POL PIER REPAIRS  
LAJES FIELD, AZORES

CONSTRUCTION INSPECTION VISIT NO. 2  
JULY 1980

CONTRACT NO. N-62477-79-C-0021  
MODIFICATION P-00001

**OLKO ENGINEERING**  
CONSULTANTS • DESIGNERS

NEW NORTH DOLPHIN  
Threading the West Wall and Driving at the Other  
Three Walls to Level the Sheet Piles

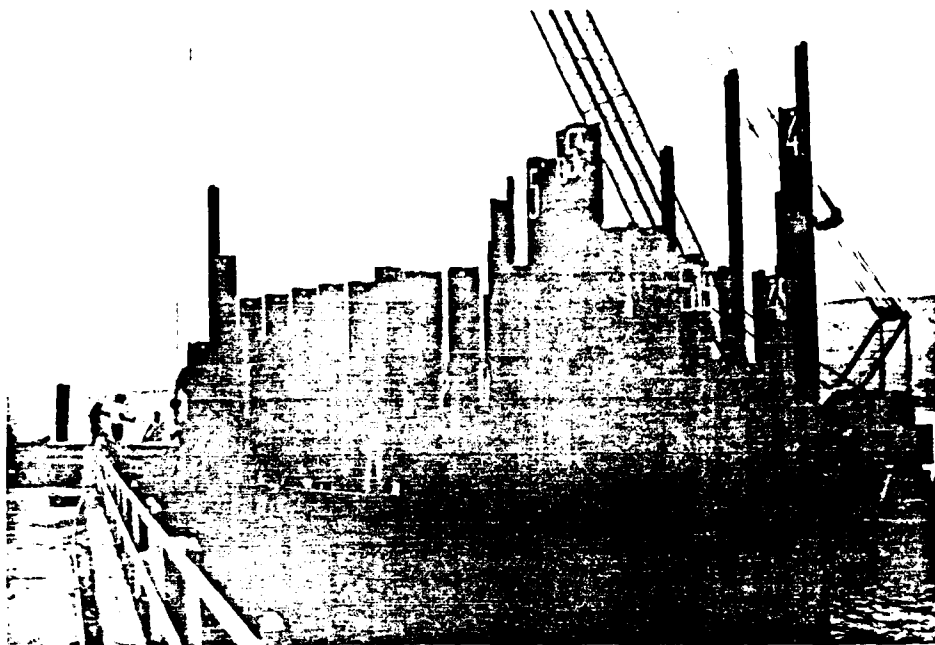
Driving of the new North sheet pile Dolphin was in progress, during the inspection visit. The Contractor was not, however, driving in level stages, but instead, was selectively driving portions of various walls, dependent on the convenient reach of the floating crane and the ease with which the piles were penetrating.

During the first day of the visit, namely, Monday, July 21, 1980, the sheet piles along the North, East and South walls varied from 20 to 40 feet above the deck of the Pier. Whereas, the West wall had not been driven at all. However, after discussion with the Contractor, the flights were being leveled so that on Friday, July 25, 1980, the three walls were more level in that they had to drive about 10 more feet on the North wall to reach design penetration: about 8 feet on the East wall, and about 12 feet on the South wall. In addition, with respect to the West wall, about 60 percent of the North end was threaded, and about 40 percent of the South end was being driven.

The main difficulty they encountered so far in driving the North Dolphin was on the South wall, where one sheet required about 100 blows to advance 3/4 of an inch. Finally, they pulled up the sheet and moved some of the adjacent sheets and then redrove with reasonable ease.

NEW NORTH DOLPHIN  
Epoxy Paint Touch Up of Abraded Sheet Piles.

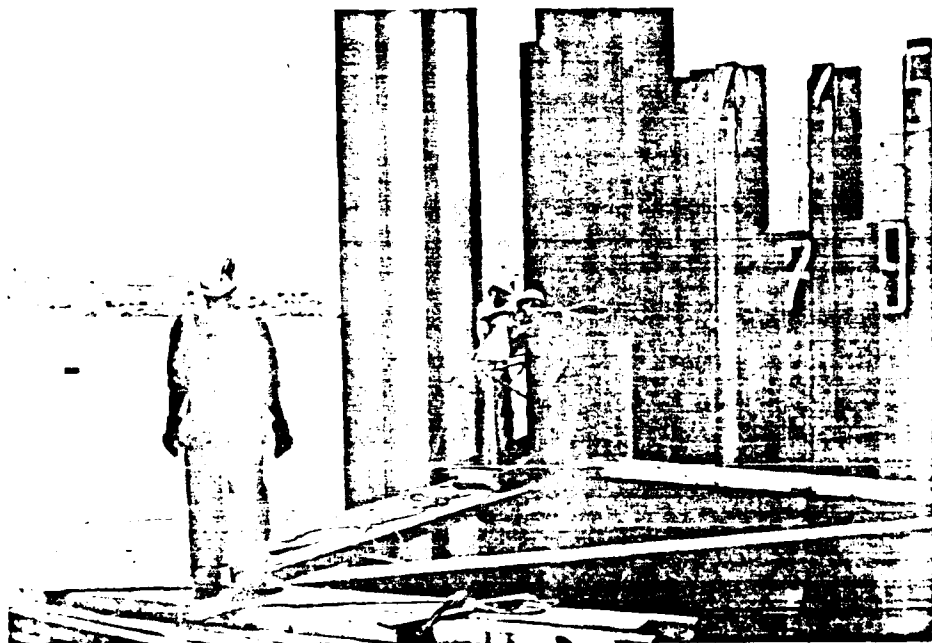
It was noted that due to handling, some of the piles were badly scraped and epoxy paint retouching was needed. Accordingly, the Contractor started this operation as the sheets were being driven. He had an epoxy paint, supposedly suitable for both above and underwater use, for touch up of the steel sheet piling. It is manufactured by American Metaseal Company, 509 Washington Avenue, Carlstadt, New Jersey 07072, telephone: (201) 933-1720.

DOLPHIN NO. 3 - ROCK ANCHORAGE  
Concrete Cap Opening Made by Drilling a Series of  
Rotary Bit Holes.

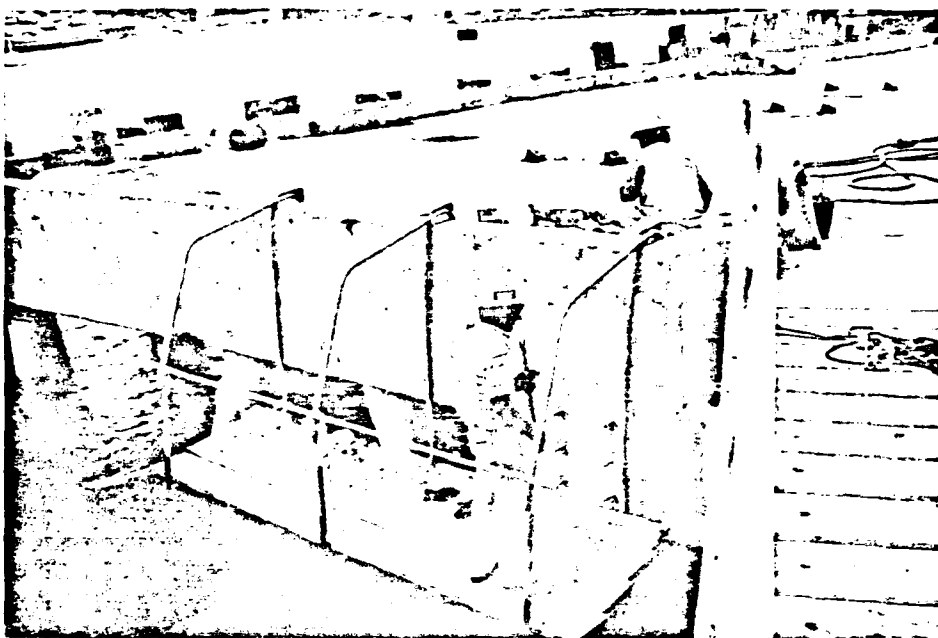
In general, since the first site visit of April 1980 there are three basic changes in the work method adopted by the Contractor. The first is that the opening in the concrete cap is made by drilling a series of holes with the percussion rotary bit, rather than jackhammering out the opening. The second change is that the Contractor is using an MKT-6 Pile Driver of 2,500 ft.-lbs. of energy to drive the casings, rather than the percussion rotary bit itself. The third change is that the Contractor is drilling into the bedrock with the 8 in. clean out bit, rather than changing over to the smaller diameter 6 in. bit.

With respect to use of the rotary bit to drill the opening in the concrete cap, this results in smooth sides which will later have to be roughened and belled out for proper bond and shear development. Also, additional side chipping is needed to expose sufficient reinforcement for butt weld splicing. This was told to the job personnel.
